Application Number: 10/612,254  
Filing Date: July 02, 2003  
Appellant(s): LAMBRIGHT, MICHAEL

**EXAMINER'S ANSWER**

Claims 1, 3-9, 11-22 is rejected under 35 U.S.C. 102(b) as being anticipated by Chandler (US 3,760,965).

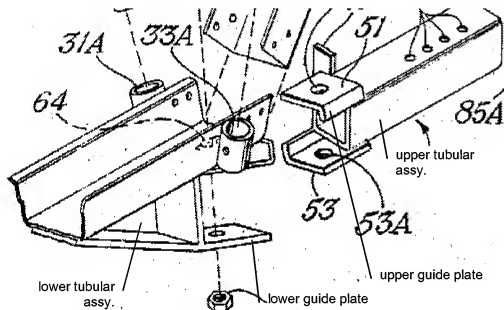
interpretation, there must merely be structure that is cylindrical but does not have to be a tube. With respect to FIG. 6 reproduced below Chandler discloses tubular structure defined by plates 23, 61 & 63 clearly define tubular structure, i.e. "consisting of a tube".

Chandler's plates 23, 61, 63 clearly have the form of a "hollow elongated cylinder".

Appellant argues that Chandler's tubular structure must be separate from that of other structure, that plates 61 & 63 cannot utilize channel 23 to complete the tube. The claims do not recite specific features of the tubular structure, i.e. tube, walls etc. Chandler's arm includes upstanding, angled walls and a base. The base of arm completes Chandler's tubular structure whereas arm comprises upstanding, angled portions. Chandler's tubular assembly 61, 63 is coupled to channel 23 thus completing the third side of lower tubular assembly. Given Appellants definition for tubular one skilled in the art would logically conclude that a third plate is unnecessary additional expense and merely connect sides 61 and 63 to arm 23 eliminating expense.

Chandler's central axis 65 is supported by both tubular members and guide plates as shown above. In addition, lower tubular assy. and guide plate rotate relative to upper tubular assy. and guide plate. FIG. 16 discloses relative motion between lower tubular assy. and guide plate about a common axis as well as a central axis of pivot 55, 65.
